Recall Bulletin 260422REV

NHTSA 26V264 TC # NA	The purpose of this Recall Service Bulletin is to inform REV Recreation Group (RRG) dealers of the need to inspect and perform needed repairs to 2026 Fleetwood Bounder, Flair, Fortis and Holiday Rambler Admiral and Vacationer motorhomes. A list of 12 affected motorhome serial numbers appears at the end of this Recall bulletin.
YEAR(S) AFFECTED: 2026	
PRODUCT(S) AFFECTED: <u>FLEETWOOD</u> BOUNDER FLAIR FORTIS <u>HOLIDAY RAMBLER</u> ADMIRAL VACATIONER	<u>CONDITION:</u> The 7000I Onan/Cummins generator may be susceptible to electrical line noise from the furnace on certain class A gas motor homes. Under normal start-up or shutdown of the RV furnace, an electrical signal may be induced going to the generator control module, turning the generator off or on. <u>DEALER CORRECTIVE ACTION:</u> This repair bulletin provided by REV RV supplies technical instructions so an authorized REV RV Dealer or Service Center technician can perform the needed repair of adding a relay harness that will plug into the existing Fleetwood/Onan harness to reduce potential of electrical line noise. Note: This REV RV Repair is to be performed by a REV RV dealership

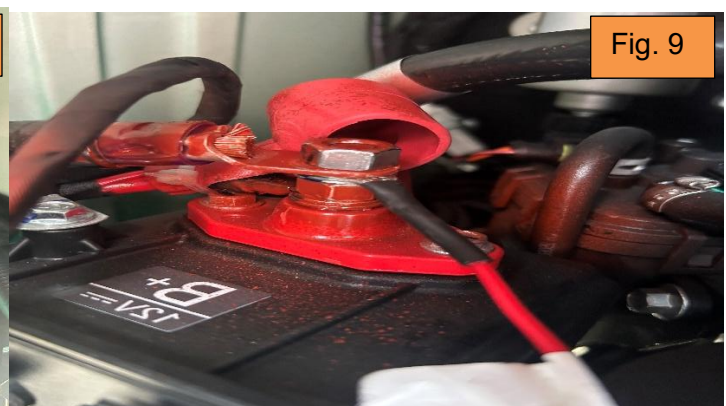
12. Attached to the original Onan harness is an 8-pin connector and harness from the body builder. Carefully disconnect the body builder section from the Onan section in preparation of adding a new inline harness. Note: Some of the original harnesses looked like Fig. 6 straight Onan to body builder harness and others have a short Onan pigtail harness as shown in Fig. 7. Do not remove the pigtail harness. Only disconnect the body builder plug from the Onan harness.

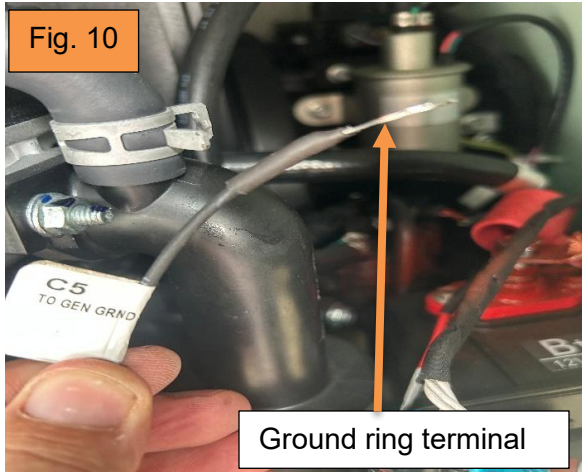
18. On the new harness locate the **black ground ring terminal tagged C5**.

19. With the black ground ring terminal in hand, locate the rubber grommet next to the positive terminal post. Push the black wire through the rubber grommet. This is the same grommet that the main body builder harness goes through.

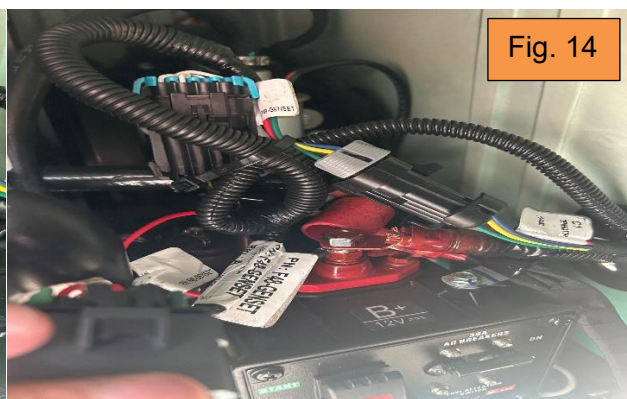
20. Next locate the ground stud under the generator (marked GND B).
21. With a ½ inch wrench, remove the nut, the existing ground cable from the stud.
22. Next install the black wire terminal from the new harness onto the ground stud. Reinstall the ground cable and nut. Tighten to 11-15ft-lbs
